**Appeal No. 3**

Vishala & Kumar Neppalli  
Residential Single-Family

The applicant requests a variance of 365 sq.ft. to allow a 1,325 sq.ft. attached accessory structure (garage) located at 4380 Westwood Road.

PRELIMINARY 7  
PLANS  
**A1**  
Copyright Dean Architects©2025

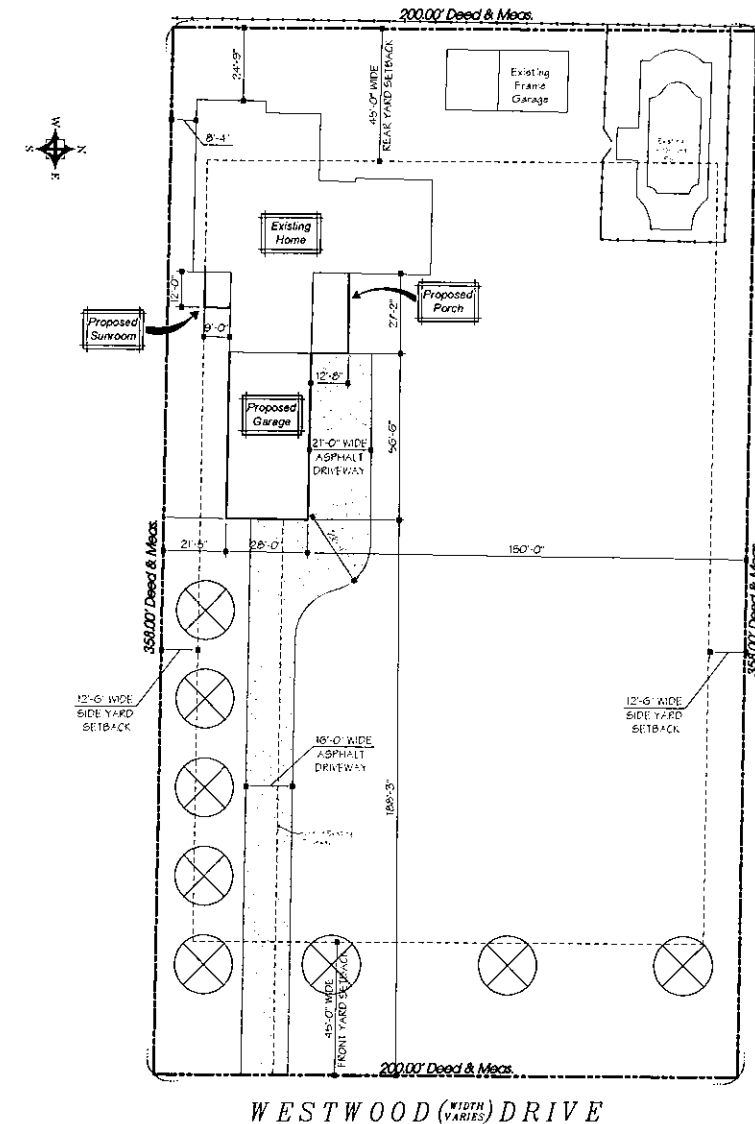
Mr. Drinkard referred to drawing A1: a small room on the side was identified as a porch.

Mrs. Neppalli clarified that is currently a kitchen bay window in the back. The window will be removed and an opening from the dining space to a three-season room with plants. A patio door will replace the window.

**A2**

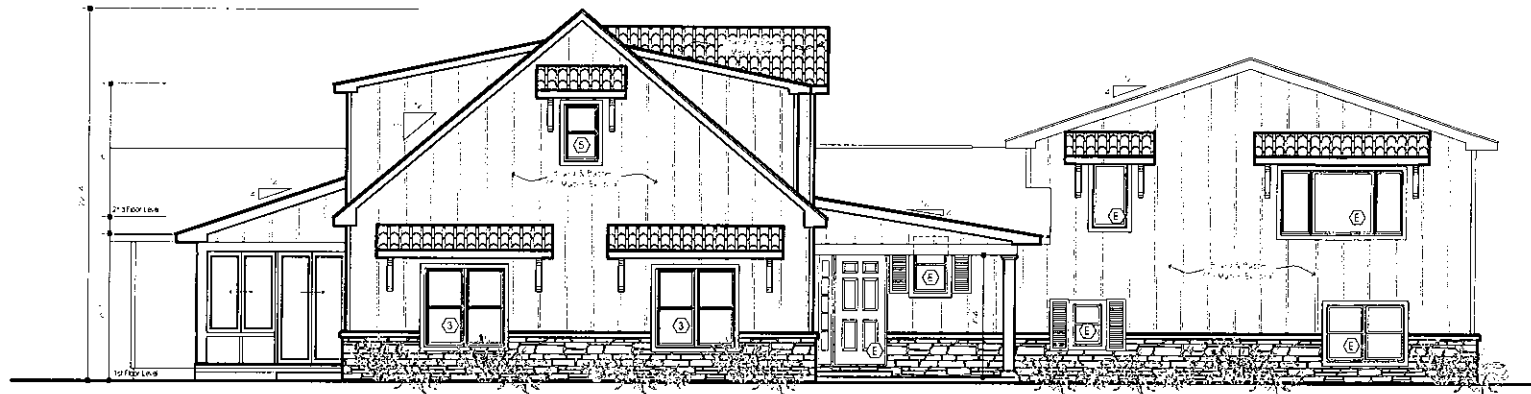
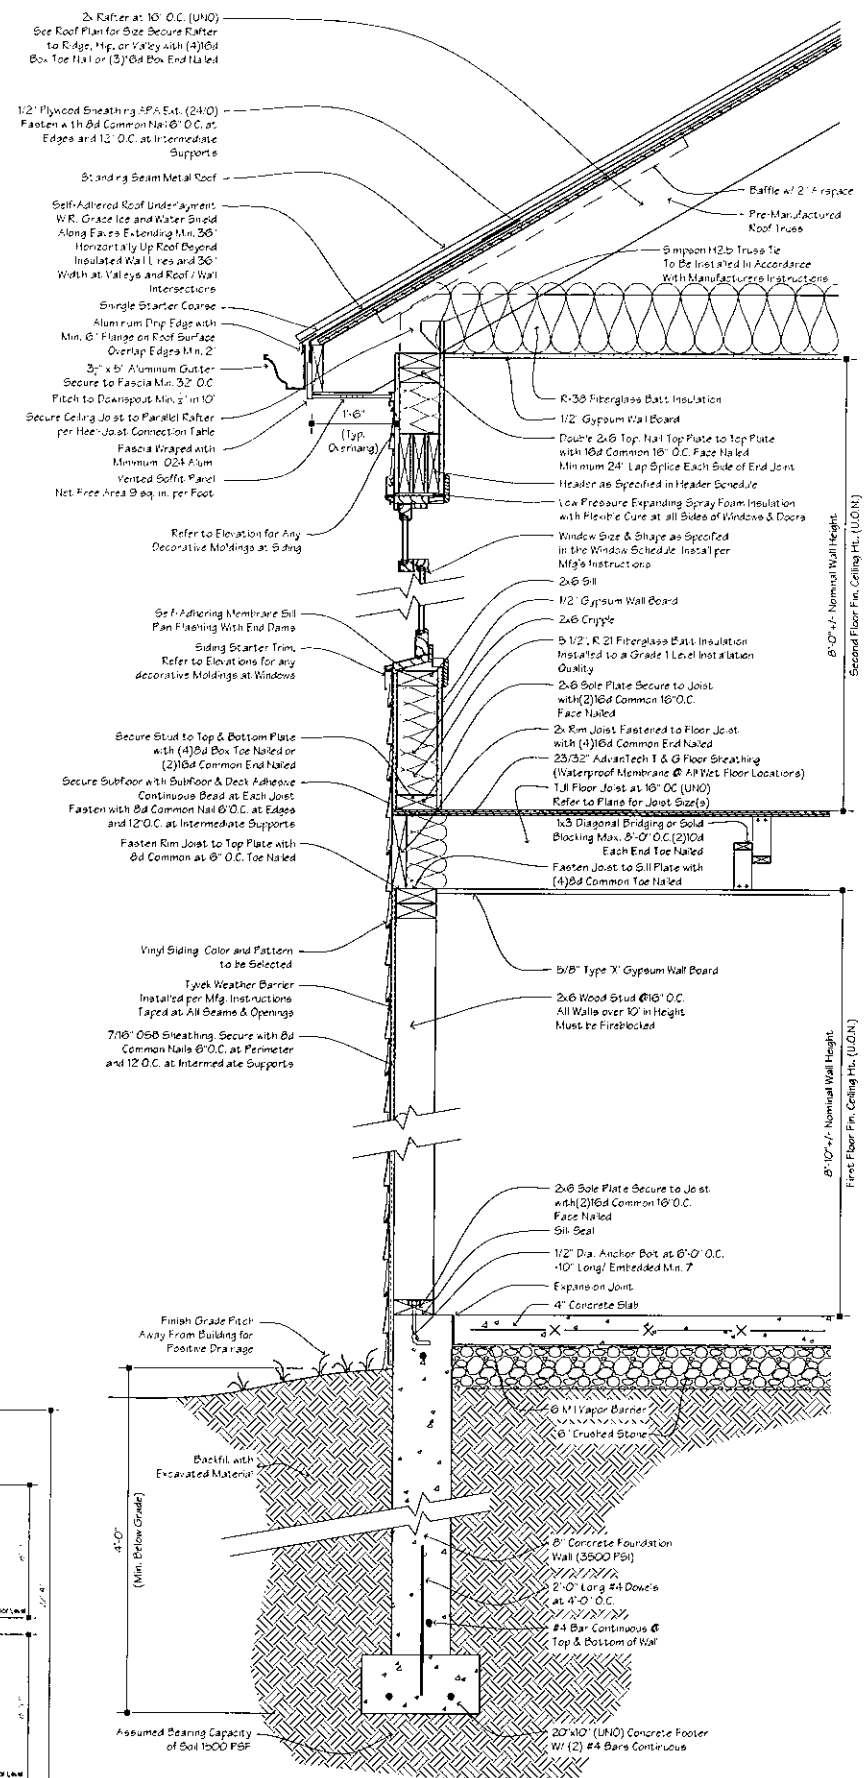
Mr. Drinkard inquired about the 12.5-foot side yard setback as shown on exhibit A2.

Mr. Bleuer stated that looking at A2, the existing side yard setback of the southside of the home is 8 ft 4 inches. However, there is no addition planned within the 12.5-foot required side yard setback.

Mr. McNamara, questioned the aesthetics of the east elevation facing the street. He stated it was very simple and very bland and this area is the front of the home and what everyone is going to be looking at per the drawings.

Mr. McNamara said he has no problem with the north side or the south side that faces the back of plaza parking lot. His only issue is with the east side of the property.

Chairman Mills stated that he shares Mr. McNamara's concern about the east elevation. He said from the aesthetic standpoint it is not great for the character or environmental conditions of the neighborhood and that is criteria that the ZBA are asked to look at. He understands that she said she was going to change it but they have to vote based on what is presented at the present meeting. The exhibit A2 left elevation #3 is not aesthetically appealing from his perspective. Charmain Mills offered for her to have the board vote on the project at this meeting or ask the board to have the project table the Appeal and come back at a later date and bring a different design.

Mr. Dale also shares the same concern of how the east elevation looks aesthetically. He suggested maybe a few more windows on both floors.

Mr. Neppalli said the setback will remain the same.

Mrs. Neppalli stated it was not going to be bland and what he was looking at was only the spec lines that were being shown to give an idea. She also explained that she has been reviewing some architectural designs and mentioned adding a large window and adding flower boxes to dress the home up.
